PROJECT: NEW ADMINISTRATIVE BUILDING FOR THE NATIONAL ASSEMBLY OF CAMBODIA

**WORK PACKAGE: MAIN CONTRACT WORK**

**SUBJECT: CLARIFICATION OF BIDDING DOCUMENTS NO.01**

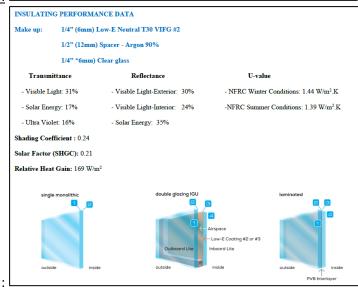
26	We found discrepancy between drawings, architectural outline specification and schedule and BOQ of Curtain Wall System, whether we use Semi-Unitized System of Unitized System.	
----	---	--

and refer to provided insulating performance data below: INSULATING PERFORMANCE DATA

Please supersede the performance data provided in Architectural Specification

5/16" (8mm) Low-E Neutral T30 VIFG #2 1/2" (12mm) Spacer - Argon 90% U-value - Visible Light: 30% - Visible Light-Exterior: 30% - NFRC Winter Conditions: 1.43 W/m<sup>2</sup>.K -NFRC Summer Conditions: 1.38 W/m<sup>2</sup>.K - Visible Light-Interior: 24% - Ultra Violet: 15% - Solar Energy: 35% Shading Coefficient: 0.24 Solar Factor (SHGC): 0.21 Relative Heat Gain: 168 W/m<sup>2</sup>
